Application for the discharge of a condition regarding planning application 3/2024/1022, allowed on appeal reference APP/T2350/W/25/3364654 on 25 September 2025.

Highcroft, Painter Wood, Whalley Old Road, Billington, Lancashire BB7 9JD.

**Planning Statement**

**Ref: JH.111225.A.2.B**

- Following shows the colour of the bronze cladding RAL 1036

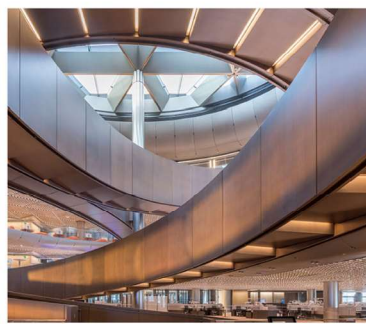
- *The sample of the bronze cladding is not sufficient and should be taken in daylight so that we can see the true colour*
- *Please clarify if the guttering will now not have the bronze cladding as per the original application?*
- *Please can you provide a photograph of a sample of the brick – there are concerns that the proposed brickwork colour is not appropriate in colour*
- *Please provide details of all external hard surfacing, not just the driveway e.g. rear patio areas, walkways, kitchen garden, fixings for the glazed balustrade and glazing opacity*
- *Please provide photographs of the natural stone flags*
- *Drawing ref: al(05)0600 does not reference zinc referred to in your statement, please clarify’*

NB The Planning Inspector, in her decision letter, concluded that *'bronze cladding would be harmonious with the adjacent row of contemporary dwellings'*

Moreover, the architect to the scheme has replied, in response to the LPA's latest comments that the submitted photograph of the proposed cladding was taken in sunlight conditions.
